HORSHAM DISTRICT COUNCIL CONSULTATION

TO:	Horsham District Council – Planning Dept
LOCATION:	Land Parcel at 519465 134242
DESCRIPTION:	Application for Approval of Reserved Matters (layout, scale, appearance, internal access and landscaping) pursuant to Condition 5 of Outline Planning Permission reference DC/16/1677 for RM Area 13 comprising 156 (C3 Use) residential units, car and cycle parking, drainage, internal roads, and associated infrastructure
REFERENCE:	DC/26/1242
RECOMMENDATION:	Advice / More info
SUMMARY OF COMMENTS & RECOMMENDATION: The application is supported by an Arboricultural Impact Assessment (AIA), Arboricultural Method Statement (AMS) and Tree Protection Plan (TPP) prepared in support of the proposed reserved matters application. The submitted information demonstrates that the layout has largely been designed around the existing arboricultural constraints present on and adjoining the site and seeks to retain all Category A and B trees; this is positive. The principal arboricultural impacts relate to incursion into the Root Protection Area (RPA) of T018, T024 and T179. The site adjoins an area of designated Ancient Woodland, and the submitted information confirms

Please see below, taken from the Drainage Layout Sheet 2 of 2 Drw No. - MOW-GLA-RM13-PH2-1202

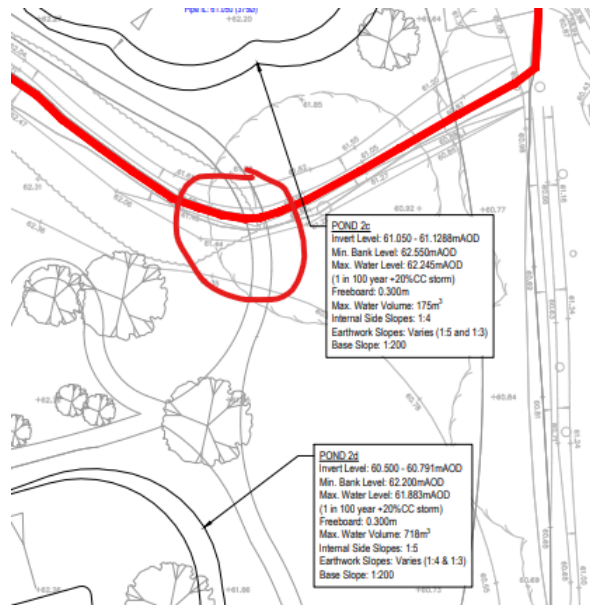
Trees T024 and T179 (Low-Dig Footpaths)

The proposed pedestrian footpaths encroach into the RPAs of T024 and T179. The submitted assessment identifies incursions of approximately 6.5% and 8% respectively. These levels are generally considered acceptable under BS5837:2012 where suitable mitigation measures are employed.

The proposed low-dig construction methodology, incorporating porous surfacing and cellular confinement systems, is in this instance considered appropriate and should help minimise impacts on the rooting environments of the retained trees.

However, whilst the direct impact of the footpath with the RPA of T024 itself appears limited, it is noted that the route crosses an adjacent ditch/shallow depression to the south, that would likely require a bridge structure or something similar to be built within the RPA of T024. As such, it would be preferable for both the footpath and any potential associated bridge structure to be located outside the RPA of the tree.

Notwithstanding the above, the outstanding concerns relating associated works within the RPA of T024 should be resolved before it can be concluded that all arboricultural impacts have been addressed in full.
